Dean Moor Solar Farm

Environmental Statement: Appendix 7.8 – Arboricultural Impact Assessment

26 August 2025
Prepared by: Stantec UK Ltd
PINS Ref: EN010155
Document Ref: D2.17
Deadline: 2
Revision: 2

Table 1.1: Revisions to Appendices B and C of the AIA

Legend

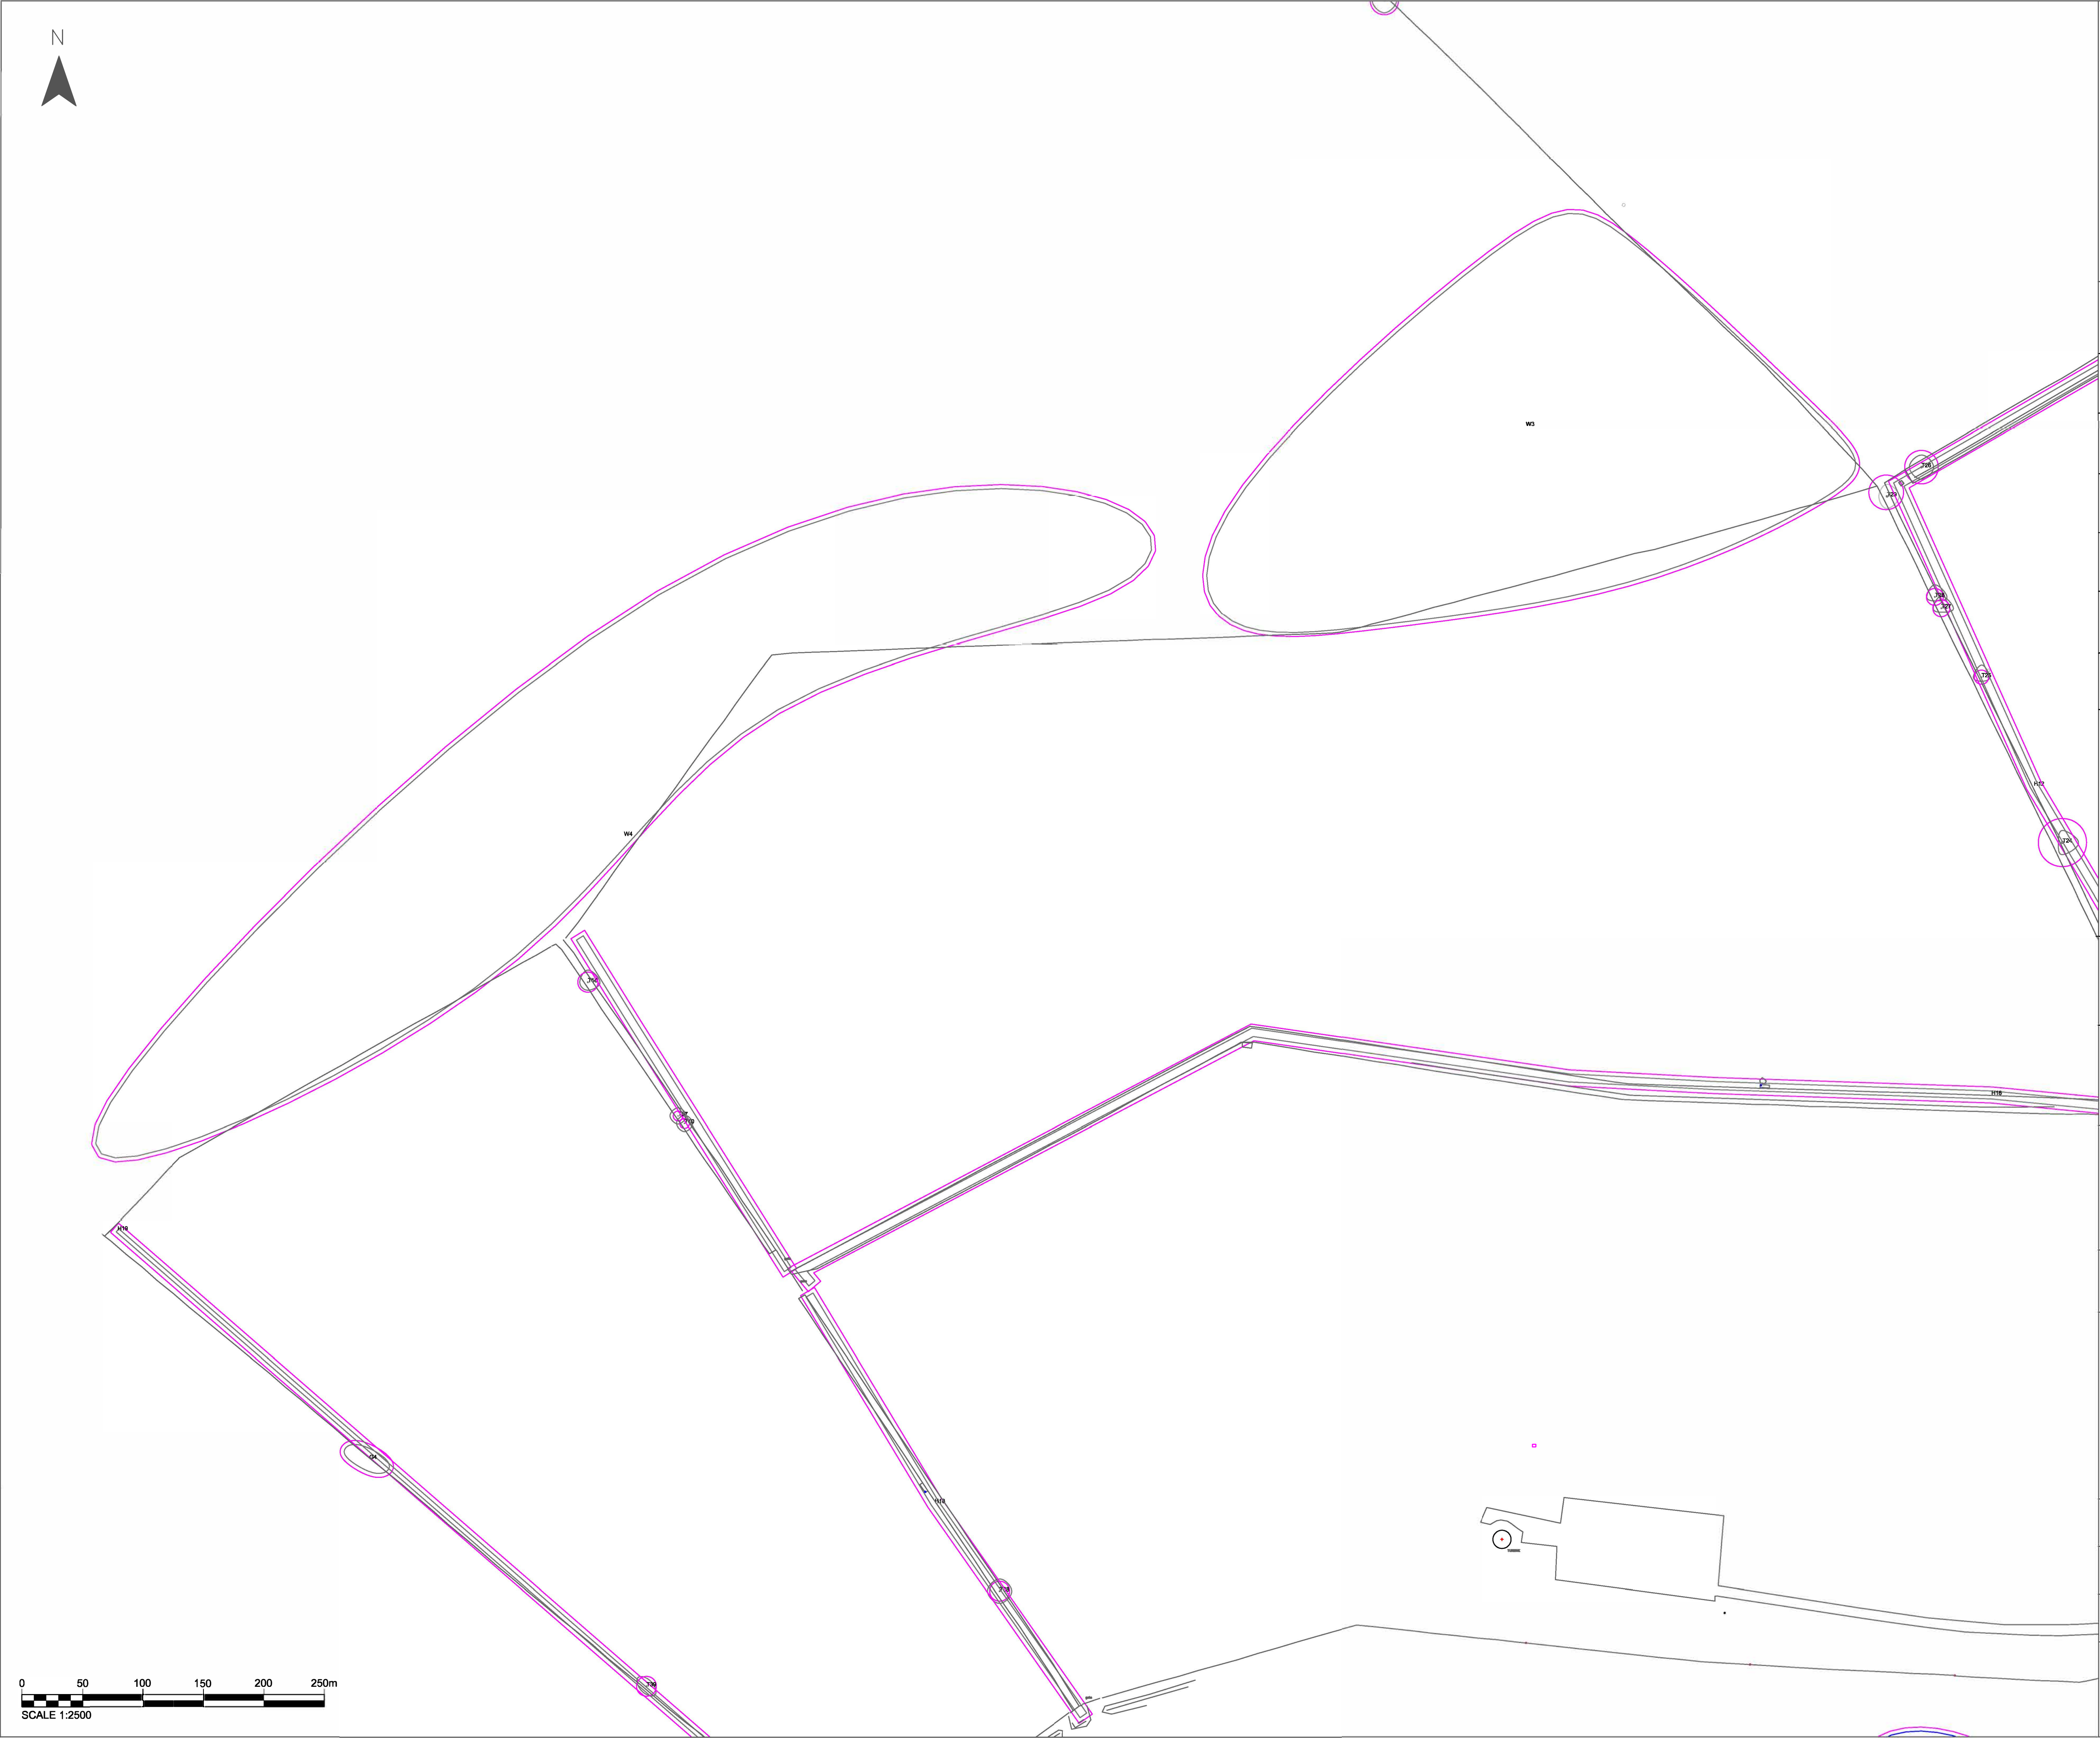
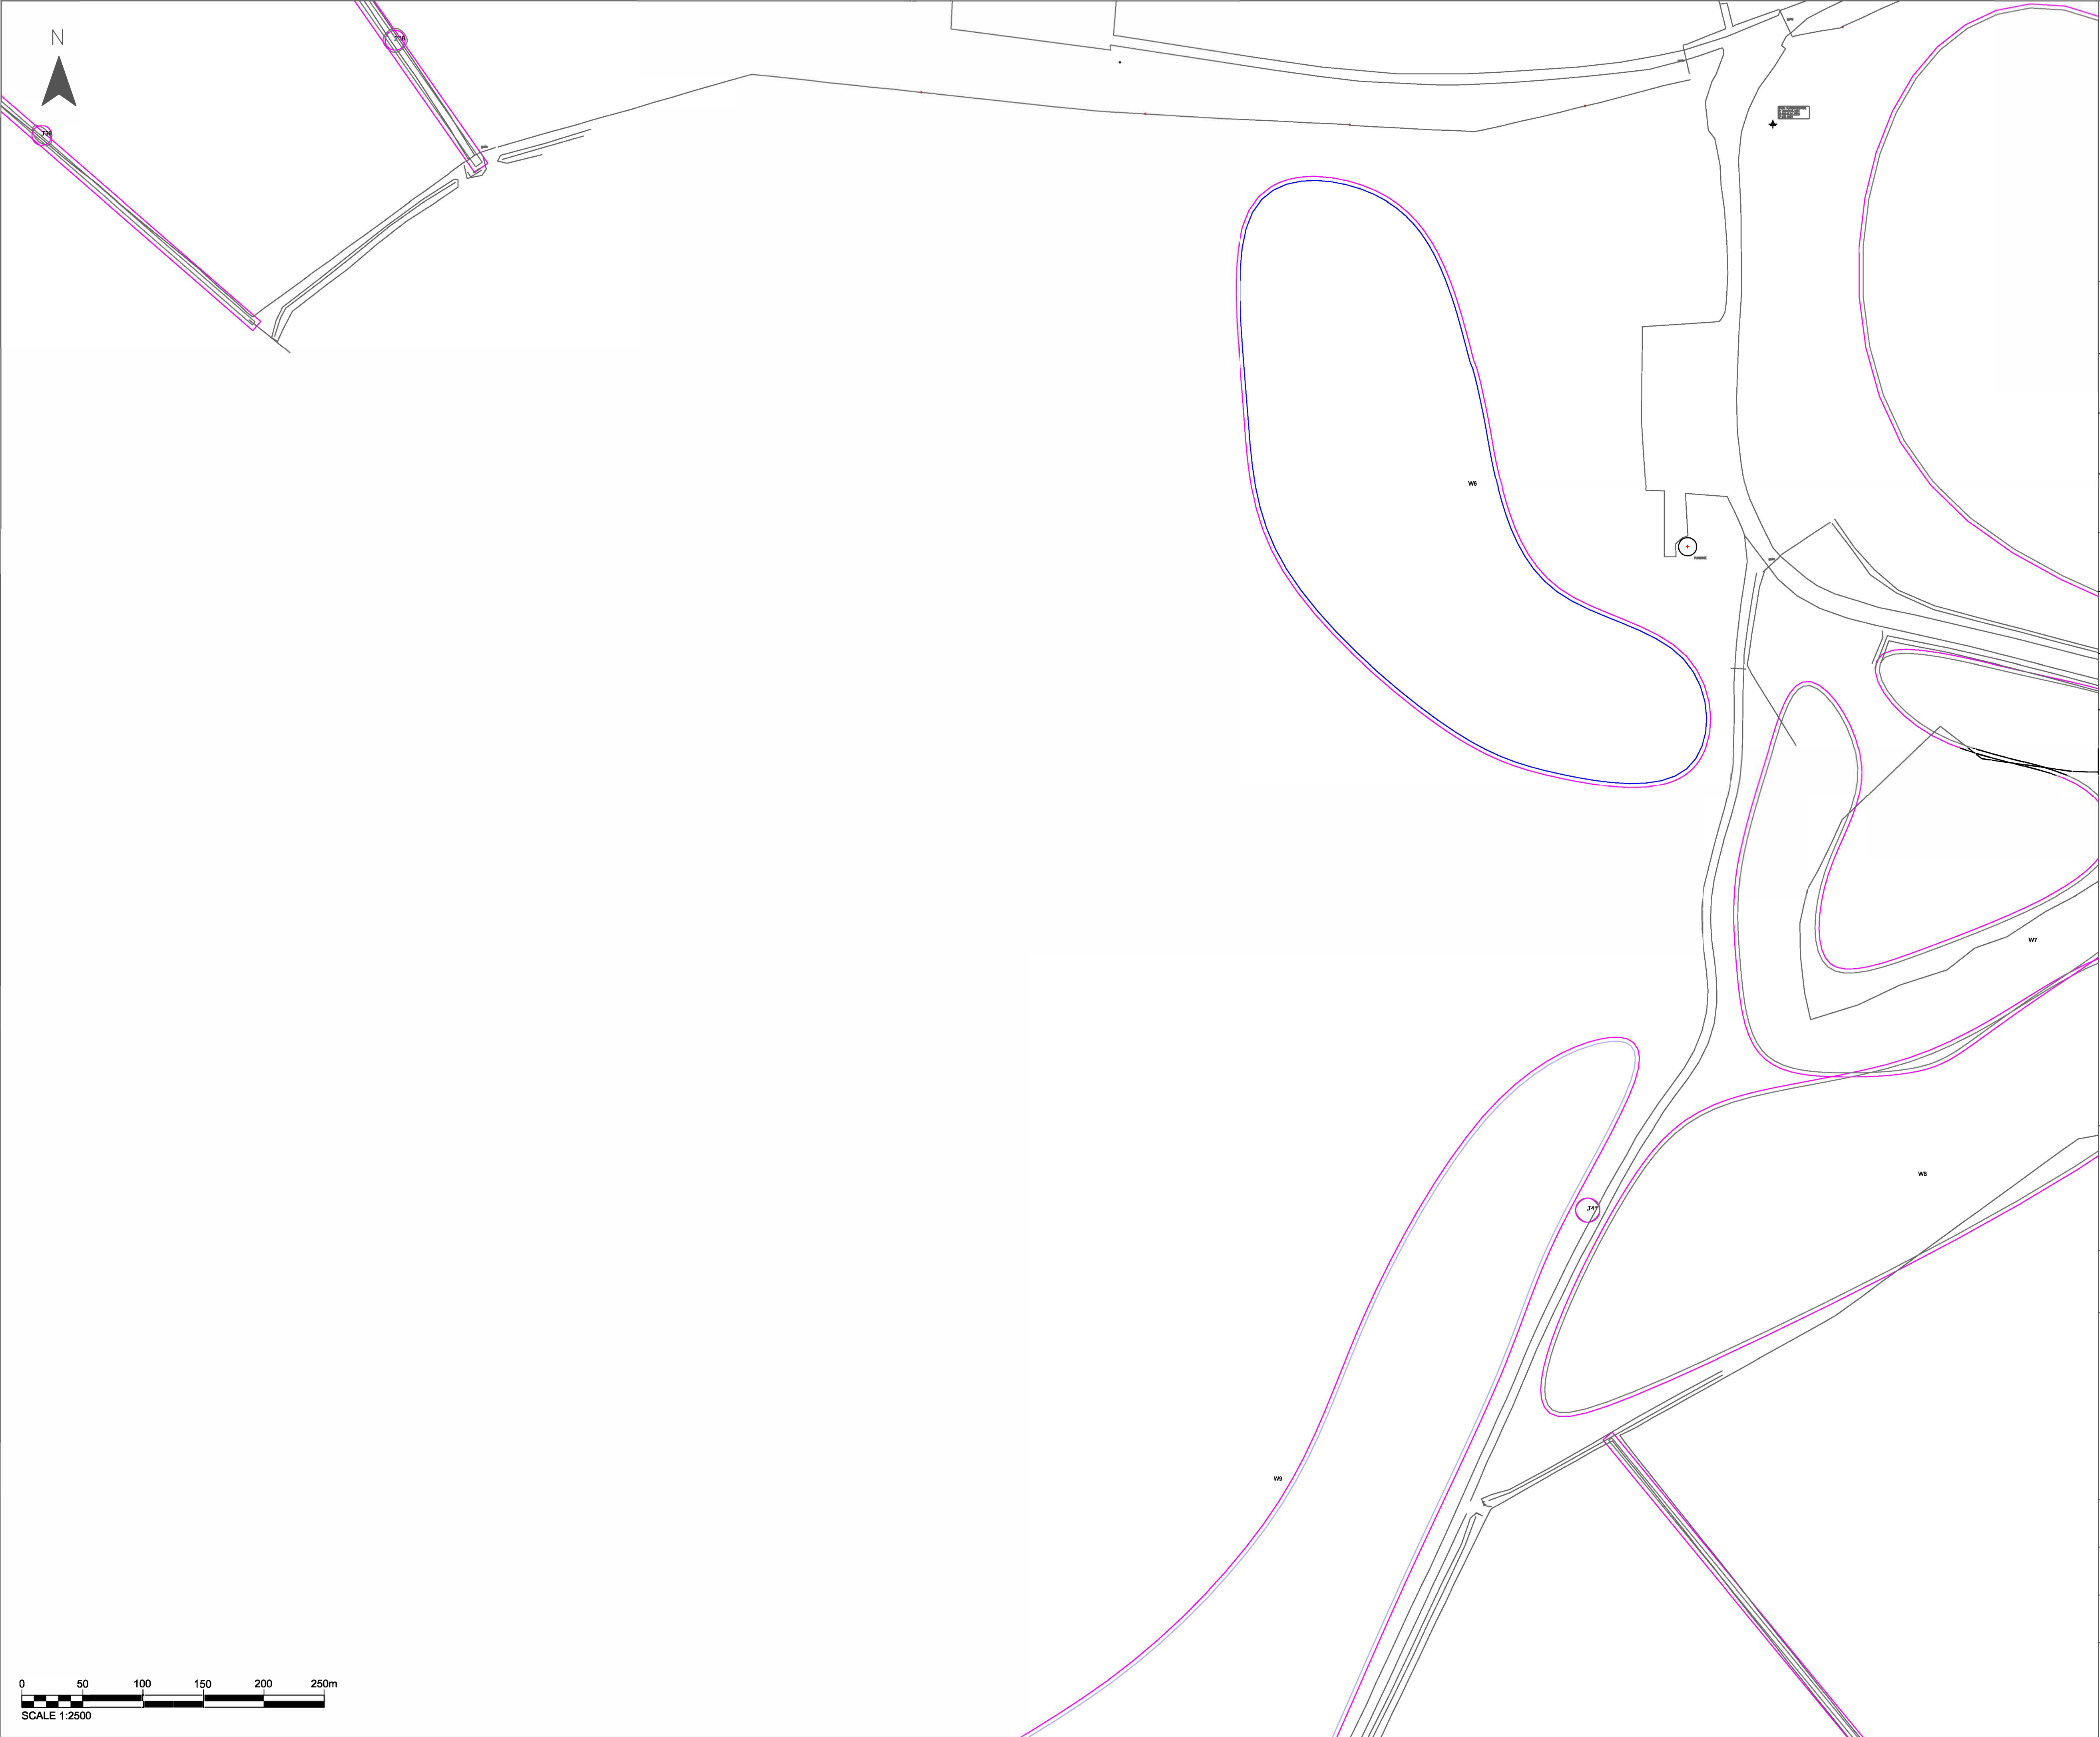
Revision	Reason
Change of the plan title in the TCP from 'Location Plan' to 'Tree Constraints Plan'	To make it clear that the plan is displaying the TCP. As the Location Plan is a different figure within the ES.
A renumbering of the sheets included in the TCP. Changing the order from 0-22 to 1-23.	To enable the first sheet within the TCP is numbered 1 rather than 0.
Change of the plan title in the TPP from 'Location Plan' to 'Tree Protection Plan'	To make it clear that the plan is displaying the TPP. As the Location Plan is a different figure within the ES.
A renumbering of the sheets included in the TPP. Changing the order from 0-22 to 1-23.	To enable the first sheet within the TPP is numbered 1 rather than 0.
